**Remarks**

This amendment responds to the official action mailed November 1, 2006, and includes a petition for extension under 37 C.F.R. §1.136(a) and the required official fee.

Docket No.: D4700-399  
[P 42231 WO/US]

FIG. 2

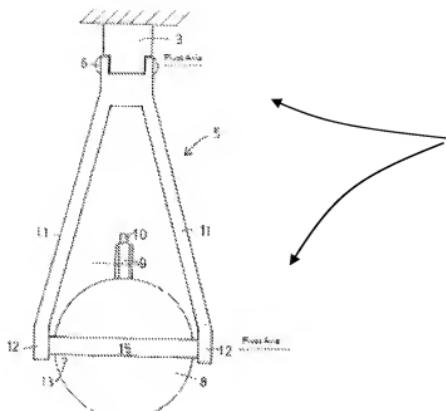
Objection was made to the drawings for lack of illustration of the various pivot axes and/or pivot angles defined in claims 3-7, 11, 16-17 and 30. Applicant proposes to show by dashed lines and to label the two pivot axes that are disclosed. There is a pivoting connection between arm 5 and console 3 at the protruding part 4 of console 3 (see paragraph [0045]), enabling the arm to be pivoted up or down over a range of 180°, which generally places the shower head 8 at a higher or lower elevation. There is a pivoting and the pivoting connection between the jaws 14 and the tips 12 of the tines 11 of the wall mounting arm 5 (see paragraph [0049]), which allows the shower head to be tilted for aiming. Whereas the pivot axes are shown, and the relationship of the arm 5 to the wall 1 and the shower head 8 to the arm 5 are illustrated, the drawings reasonably illustrate the pivot axes and pivot angles that are defined in the claims. Reconsideration and withdrawal of the objections are requested.

Add dashed lines and labels for Pivot Axes

Applicant has resolved this matter by changing the term “gripping” to “grasping” at claim 29 and paragraph [0035]. In the embodiments shown in Figs. 2 and 6, the tensioning component 15 has a cross member between the ends 12 of the tines 11, or extending laterally from one of the ends 12 to a knob. When the shower head is removed, a person can manipulate the arm by gripping it at the tensioning component. Applicant finds no basis in the disclosure to suggest that the tensioning component might itself grip the arm when the shower head is removed, but nevertheless has obviated the issue by using the term “grasp.” Although “grip” and “grasp” may be synonyms, the implication of the term “grasp” is gripping by a person as opposed to by a mechanism. The grounds for the rejection under 35 USC 112 are overcome. No new matter is presented.

FIG. 6

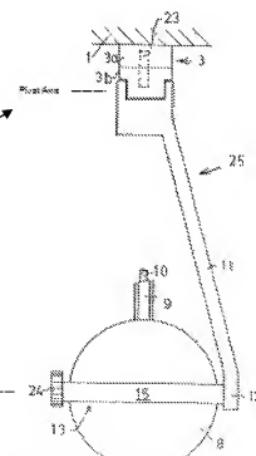
Add dashed lines and labels for Pivot Axes
